ADDENDUM No.3

HERITAGE HIGH SCHOOL

CITY OF LYNCHBURG BID NO.: 14-896
LYNCHBURG CITY SCHOOLS C.I.P. NO.: YS032
3020 WARDS FERRY ROAD
LYNCHBURG, VIRGINIA 24502

FEBRUARY 28, 2014

AD3 FIRST FLOOR PLAN - PART A - LIGHTING

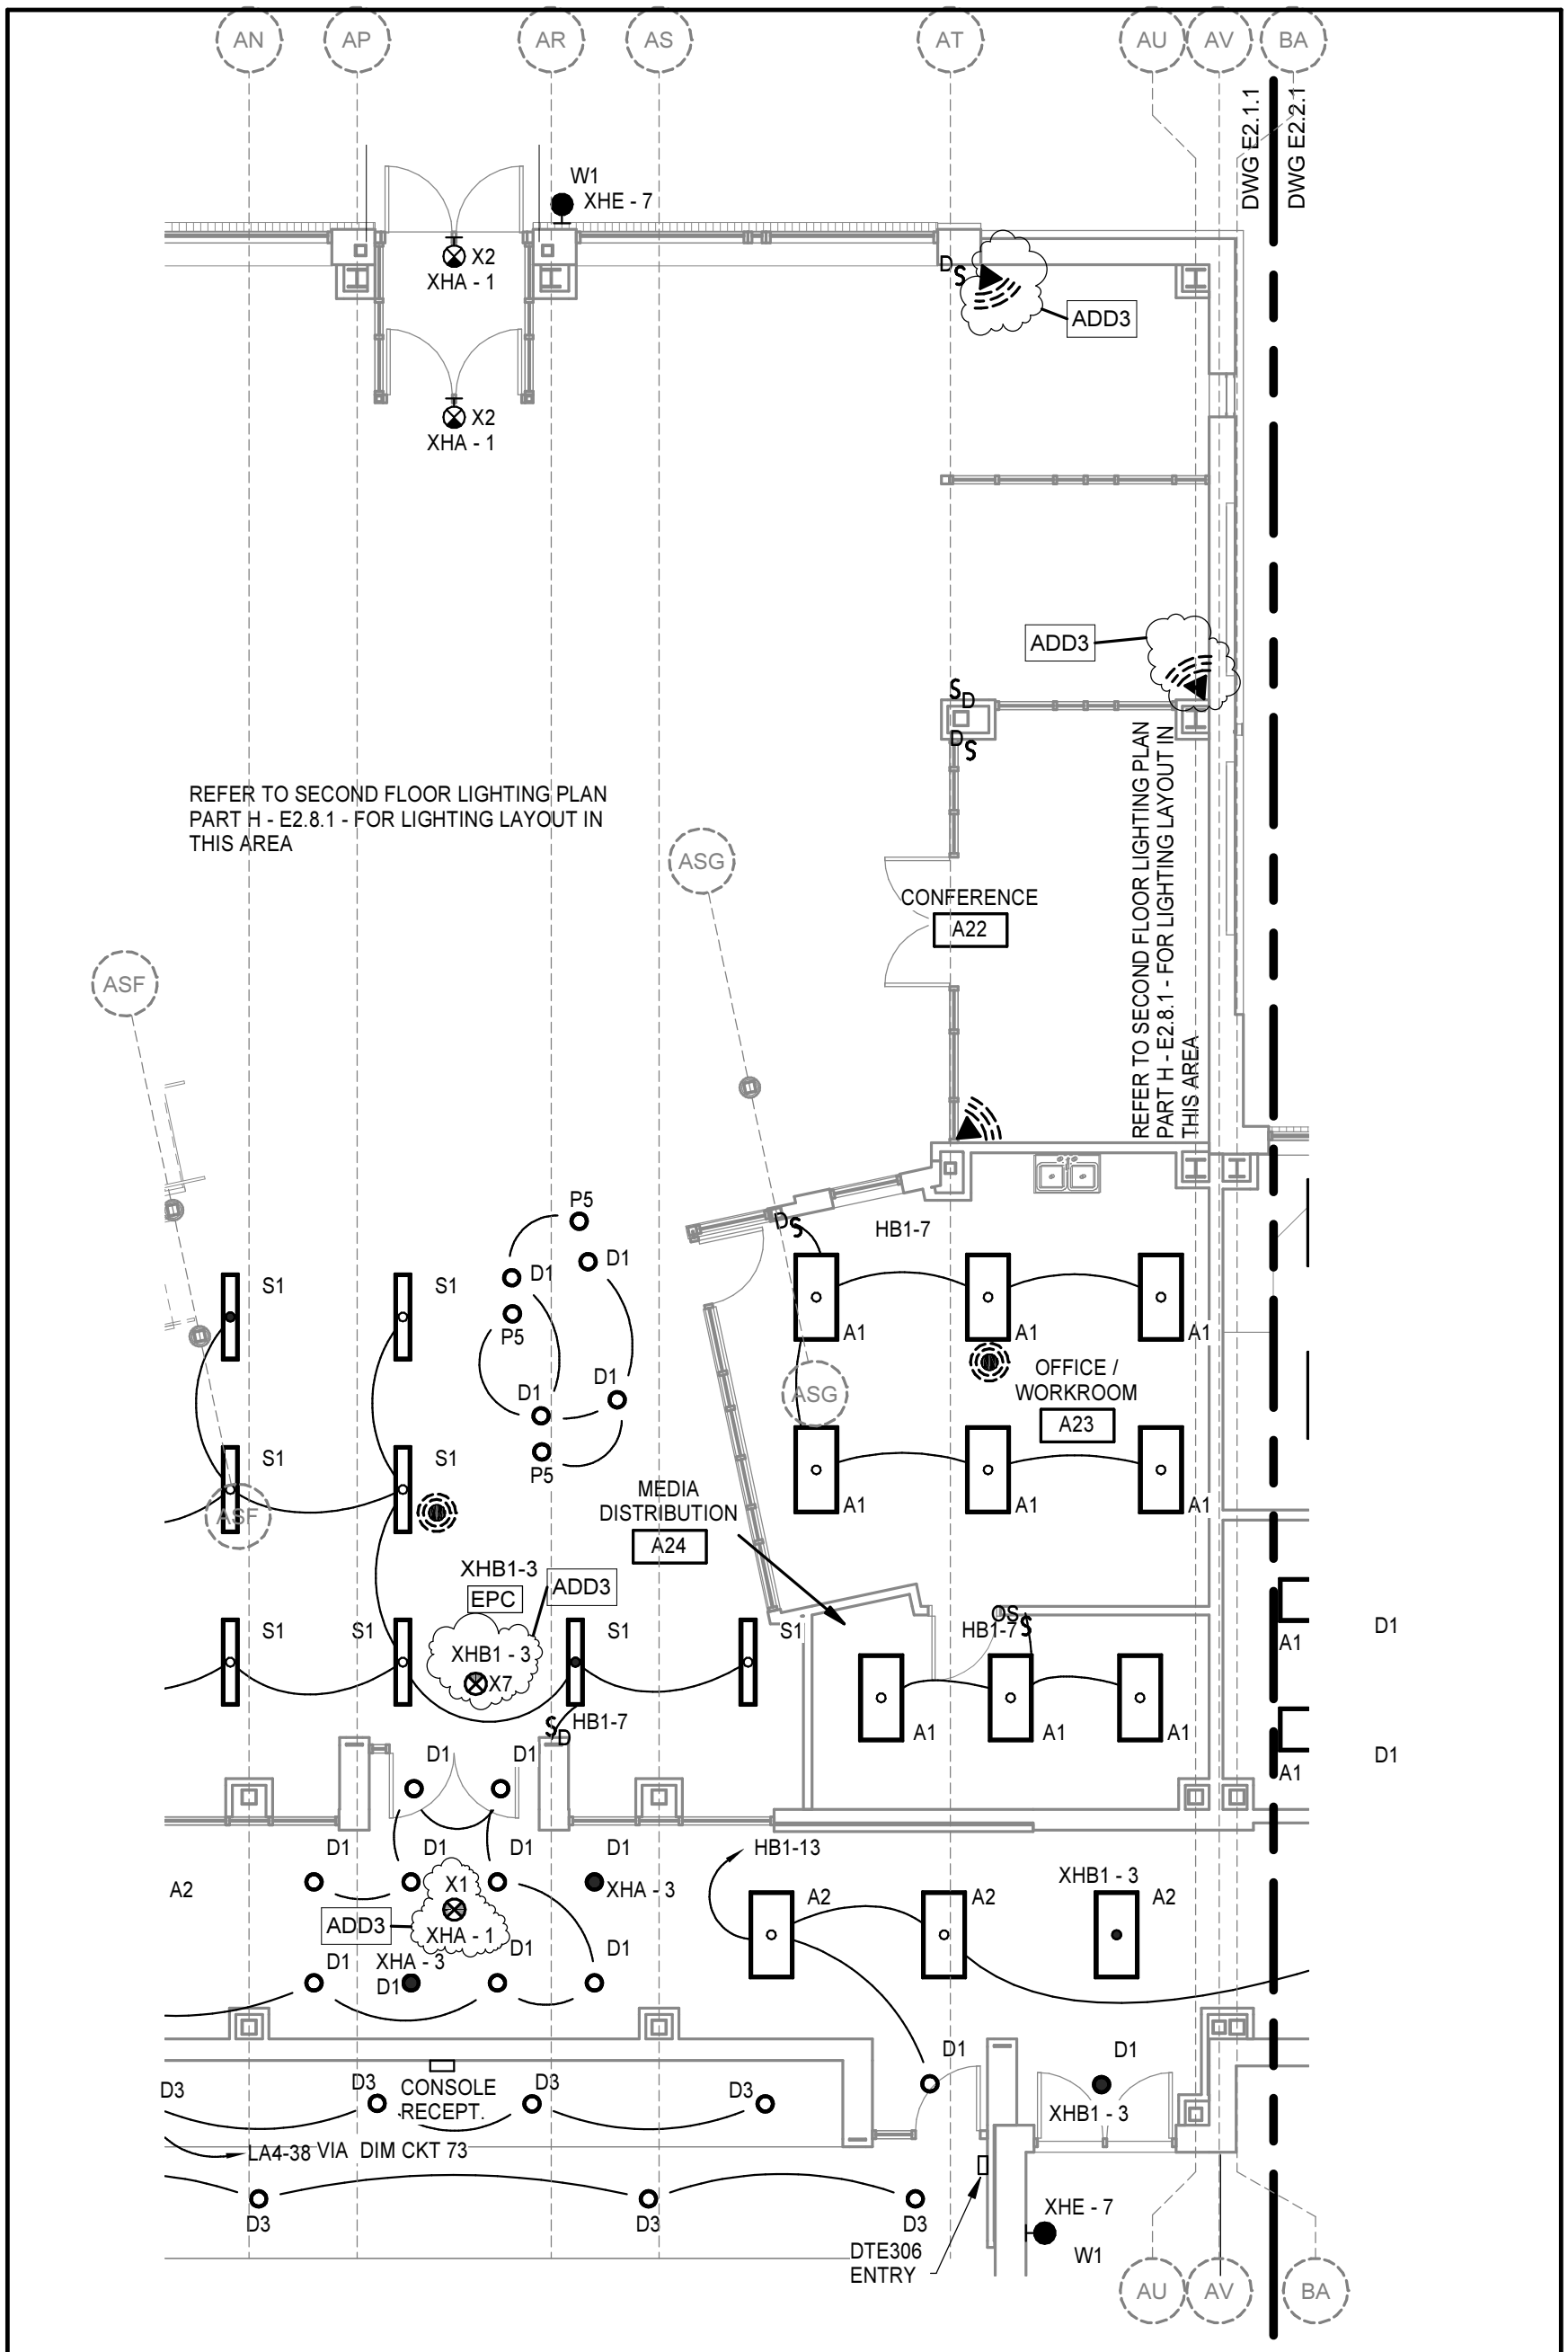
DRAWING E2.1.1:

1. Revise Part A Lighting per sketch AD3-E2.1.1-1.

DRAWING TITLE:	CONTRACT DWG NO.:	PROJECT:
REVISIONS TO PART C POWER	**E2.3.2**	**HERITAGE HIGH SCHOOL** **3020 WARDS FERRY ROAD, LYNCHBURG, VA 24502**

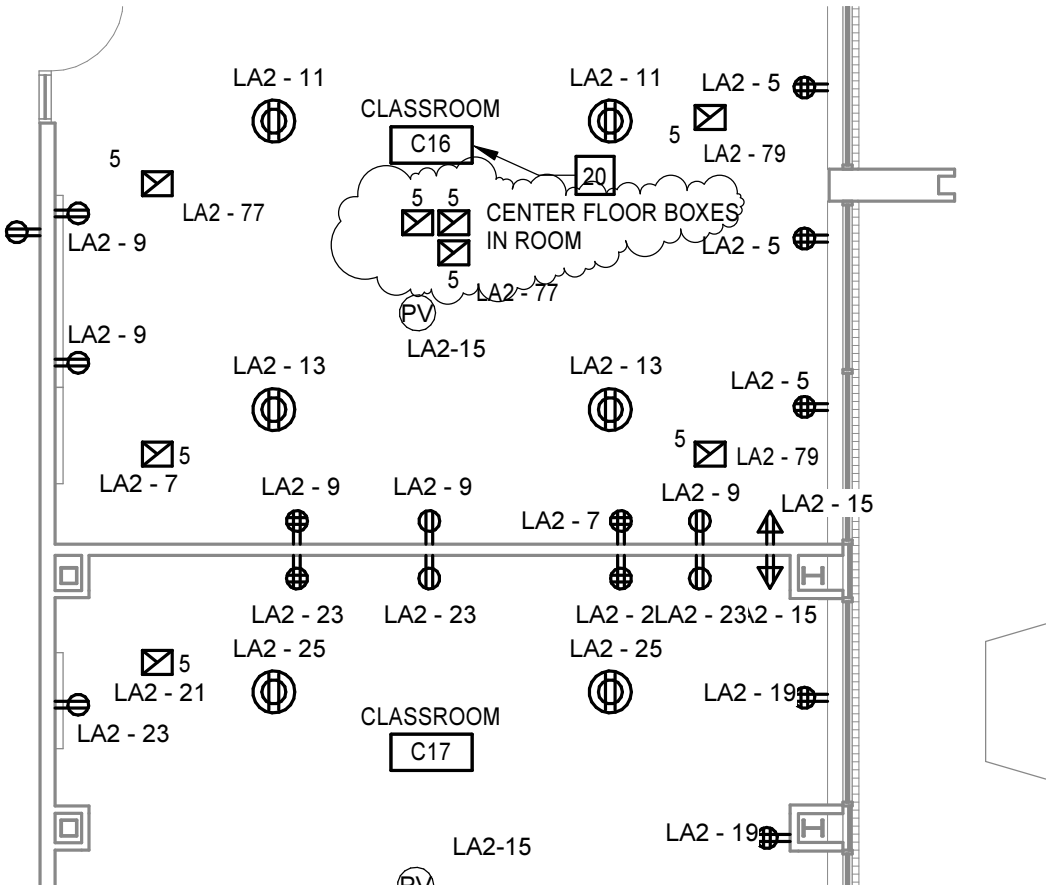
DRAWING E2.3.2:

1. Revise Part C Power Classroom C16 (Collaboration Space) to have three (3) floor boxes instead of only one (1) per sketch AD3-E2.3.2-1.

DRAWING TITLE:	CONTRACT DWG NO.:	PROJECT:
REVISIONS TO PART D POWER	**E2.4.2**	**HERITAGE HIGH SCHOOL** **3020 WARDS FERRY ROAD, LYNCHBURG, VA 24502**

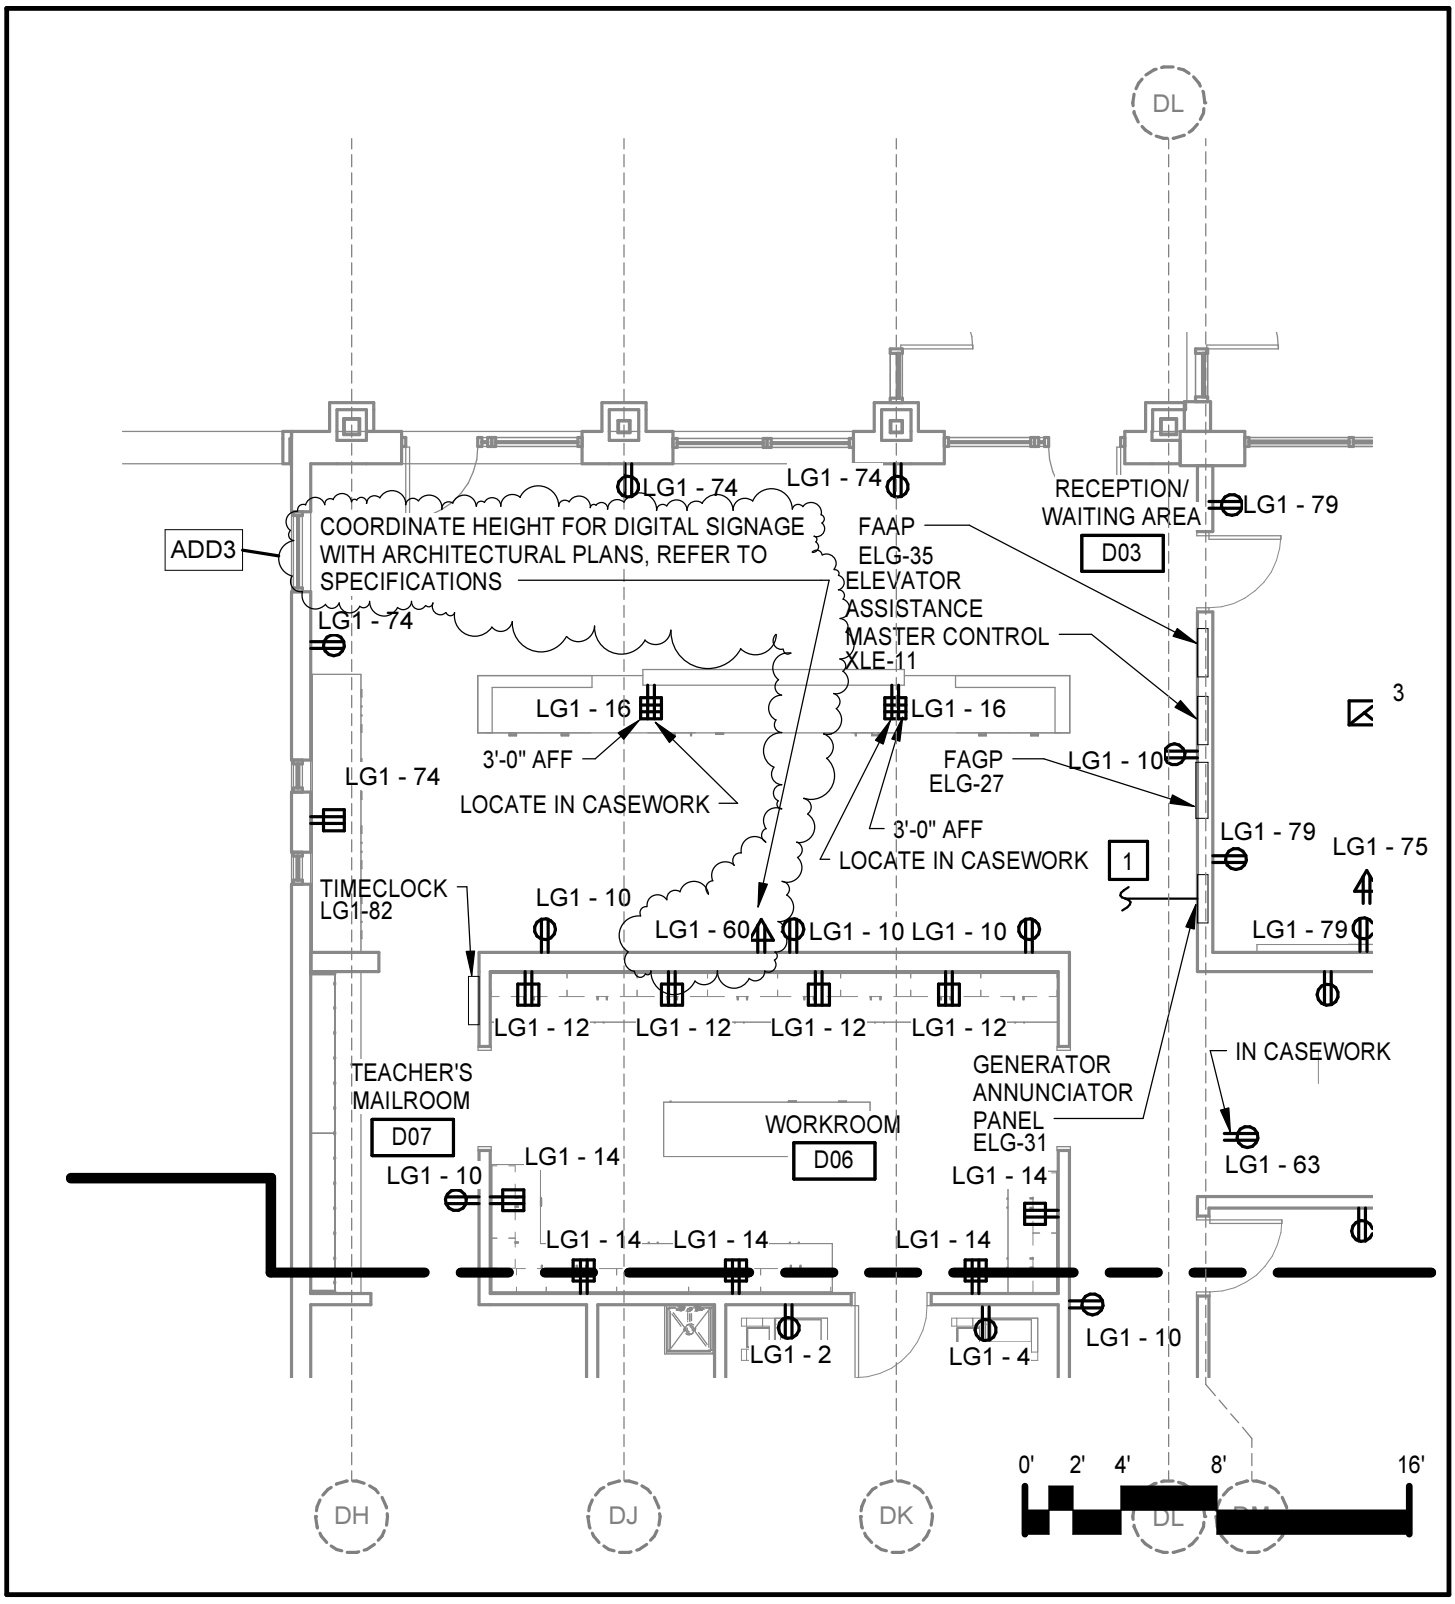
DRAWING E2.4.2:

1. Revise Part D Power Admin D03 per sketch AD3-E2.4.2-1.

DRAWING TITLE:	CONTRACT DWG NO.:	PROJECT:
REVISIONS TO PART E POWER	**E2.5.2**	**HERITAGE HIGH SCHOOL** **3020 WARDS FERRY ROAD, LYNCHBURG, VA 24502**

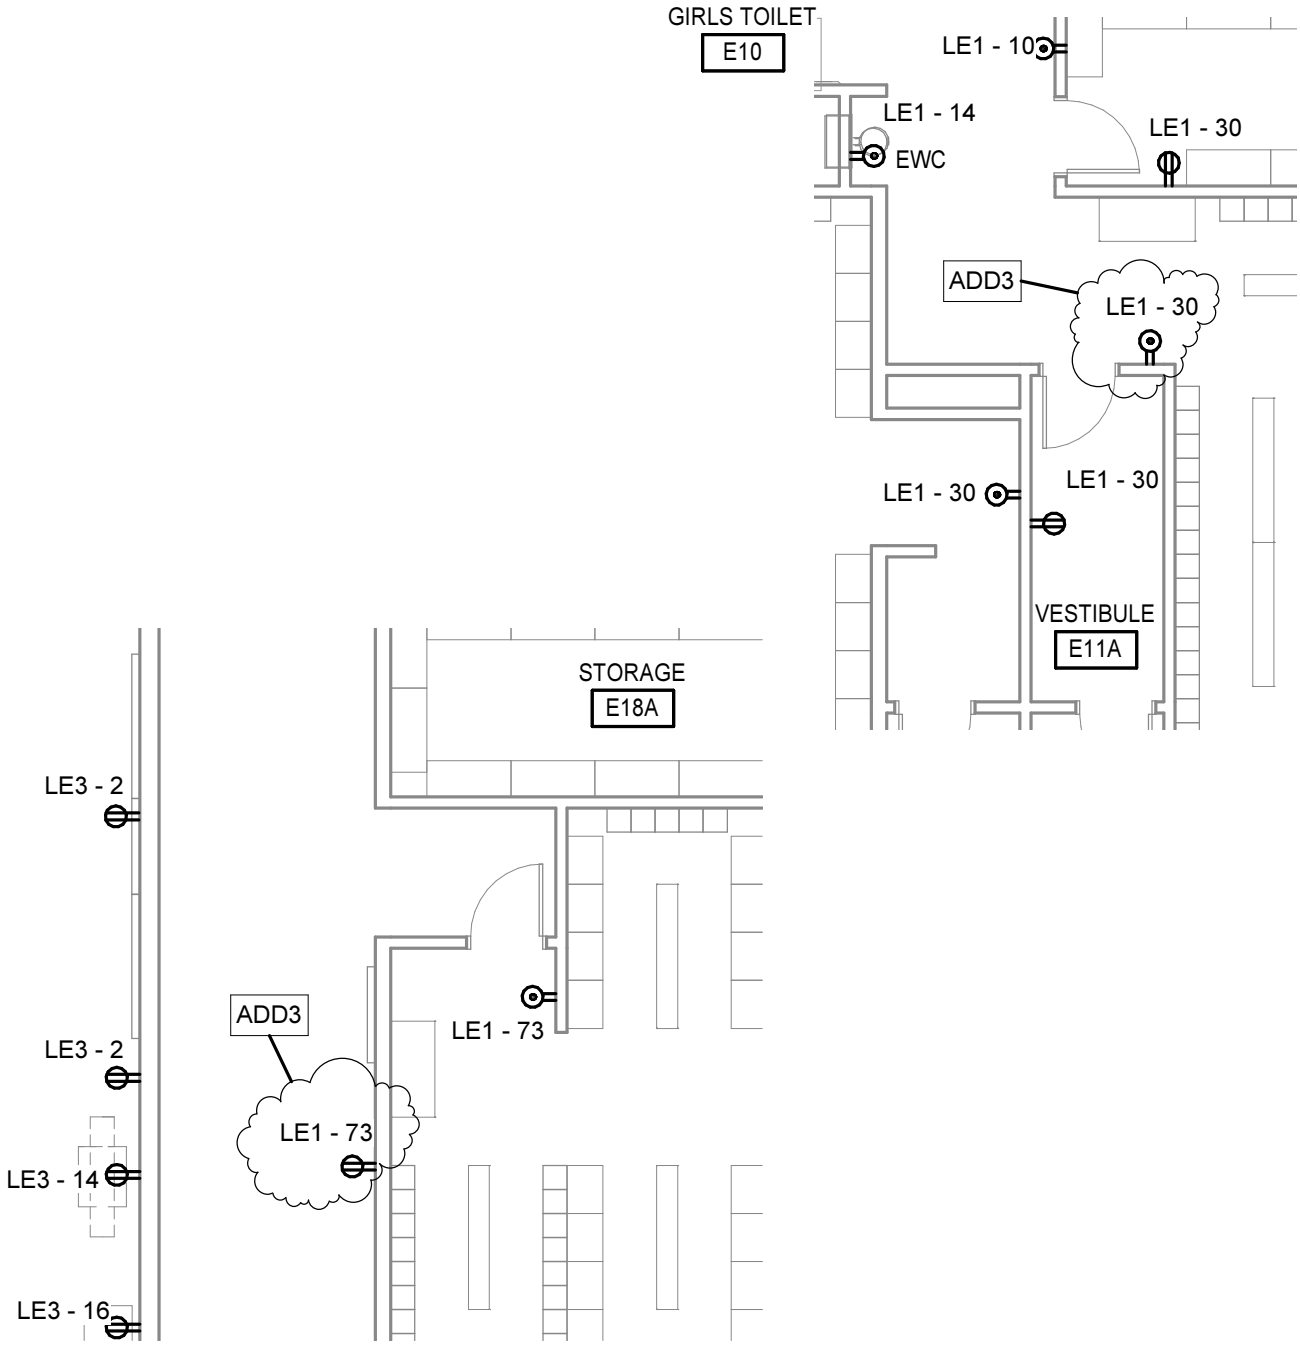
DRAWING E2.5.2:

1. Revise Part E Power indicated circuit number for two (2) receptacles per sketch AD3 –E2.5.2-1.

DRAWING TITLE:	CONTRACT DWG NO.:	PROJECT:	DRAWN BY:	ATTACHMENT TO:	SUPPLEMENTAL DWG. NO:
REVISIONS TO PART J POWER	**E2.9.2**	**HERITAGE HIGH SCHOOL** **3020 WARDS FERRY ROAD, LYNCHBURG, VA 24502**	**JAT**	**AD3**	**AD3-E2.9.2-1**
			DATE: **02/28/14**	PROJECT NO: **520910**

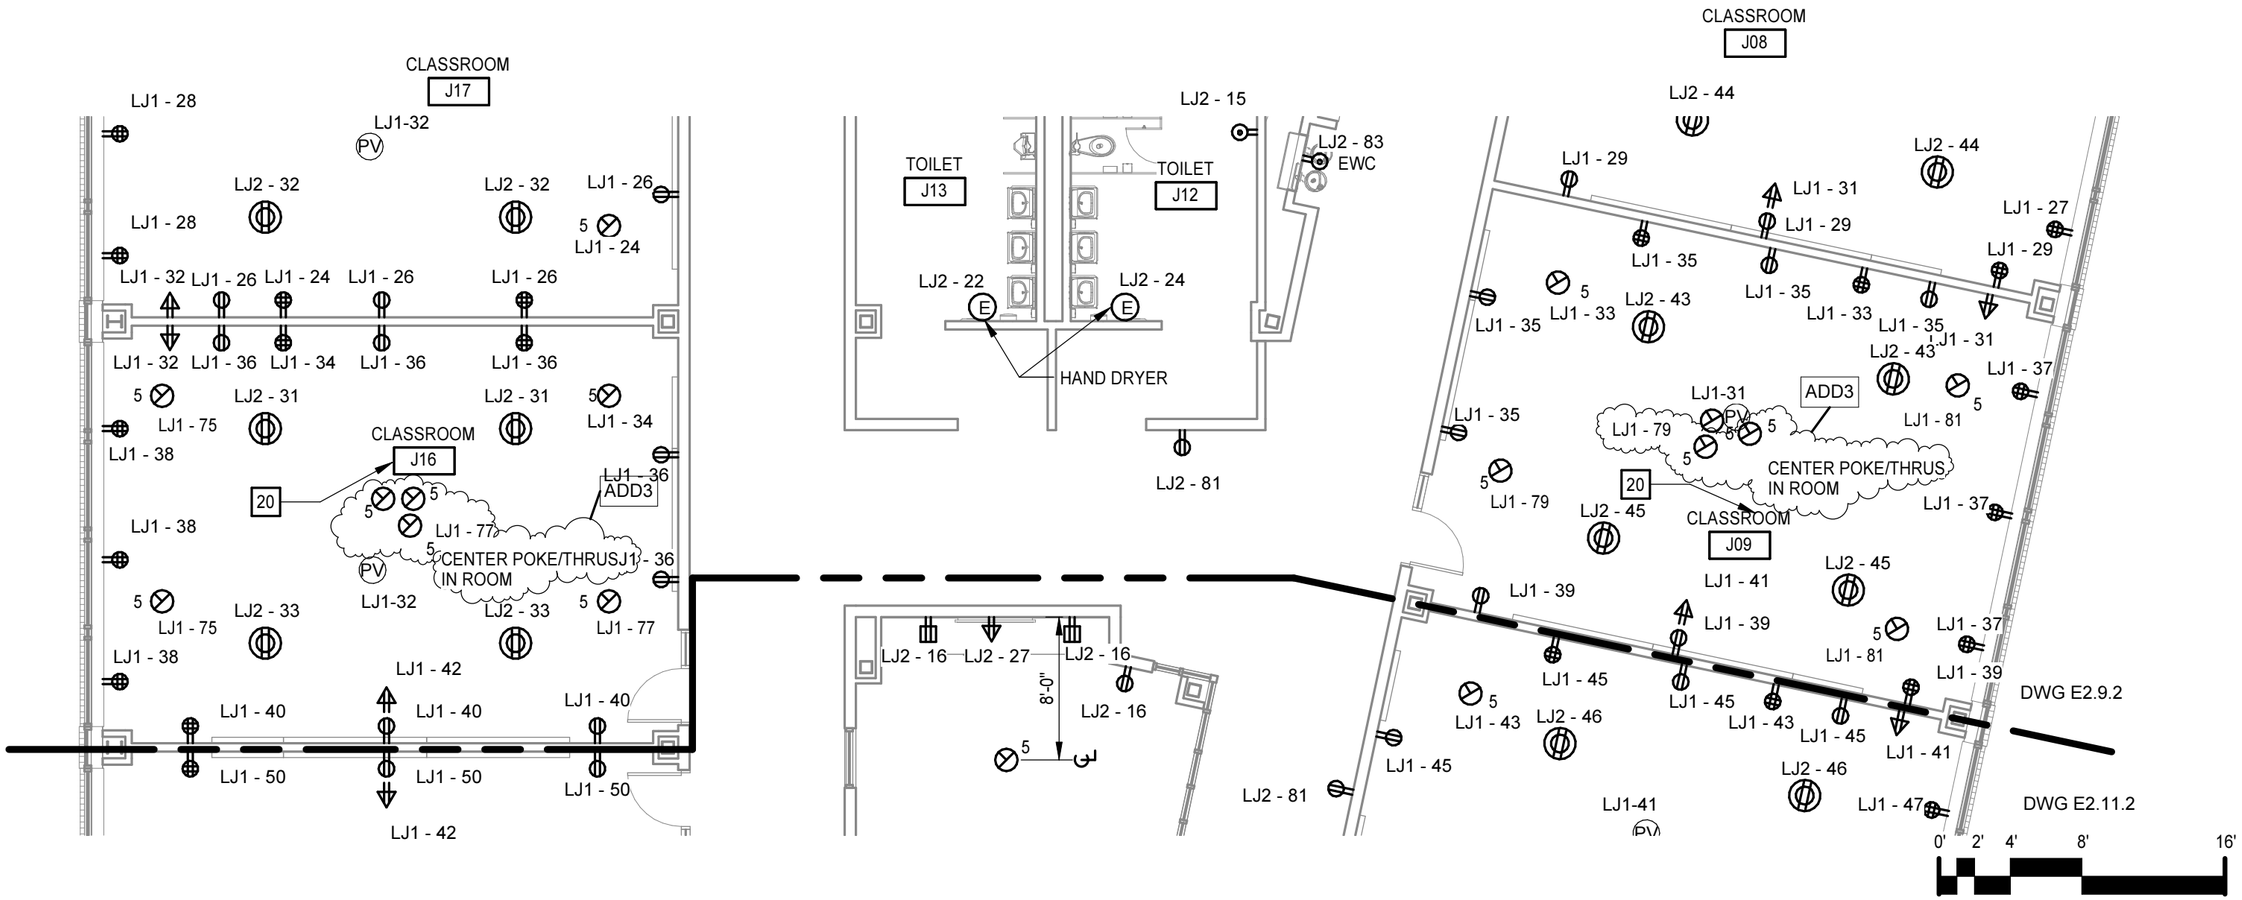
DRAWING E2.9.2:

1. Revise Part J Power Classroom J09 and J16 per sketch AD3-E2.9.2-1.
